UNITED STATES PATENT AND TRADEMARK OFFICE

Office Action Summary	Application No. 10/803,201	Applicant(s) SHMAENOK, LEONID	
	Examiner IRAKLI KIKNADZE	Art Unit 2882

DETAILED ACTION

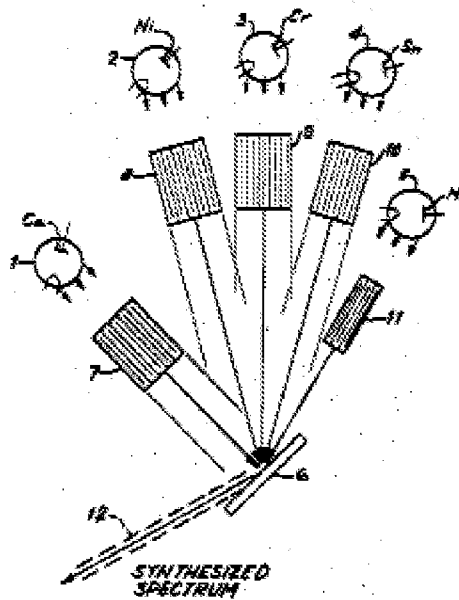
7. Claims 12, 14 and 21 are rejected under 35 U.S.C. 102(b) as being anticipated by Spielberg et al. (US Patent 3,418,467).

With respect to claim 12, Spielberg teaches a filter (7, 8, 9, 10 or 11) for suppressing undesired atomic and microscopic particles which are emitted by a

radiation source (1, 2, 3, 4 or 5),

wherein a plurality of plates are positioned substantially parallel in relation to one another, for trapping atomic and microscopic particles on their respective surfaces, wherein the plates are directed away from the radiation source (column 2, lines 47-52; it has been held that a recitation with respect to the manner in which a claimed apparatus is intended to be employed does not differentiate the claimed apparatus from a prior art satisfying the claimed structural limitations).

With respect to claims 14 and 21, Spielberg teaches that the plates are positioned such as to be evenly distributed in relation to one another (see figure) and a surface of the plates is rough (since the claim is directed for trapping atomic and

FIG. 4

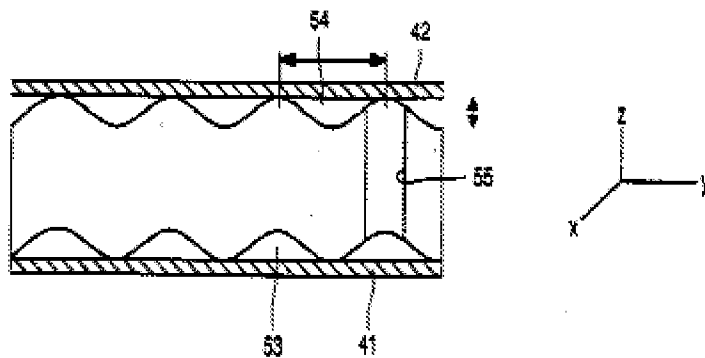
With respect to claim 12, Prins teaches a filter (5) for suppressing undesired atomic and microscopic particles which are emitted by a radiation source (1) (Figs 1 and 4),

wherein a plurality of plates (41 and 42) are positioned substantially parallel in relation to one another, for trapping atomic and microscopic particles on their respective surfaces, wherein the plates are directed away from the radiation source (column 4, lines 20-23 and 51-55; column 5, lines 27-38; it has been held that a recitation with respect to the manner in which a claimed apparatus is intended to be employed does not differentiate the claimed apparatus from a prior art satisfying the claimed structural limitations).

With respect to claims 14 and 21, Prins teaches that the plates are positioned such as to be evenly distributed in relation to on another (see Figures 4-6) and a surface of the plates is rough (since the claim is directed for trapping atomic and microscopic particles, for this minuscule level the surface of plates are always relatively rough).
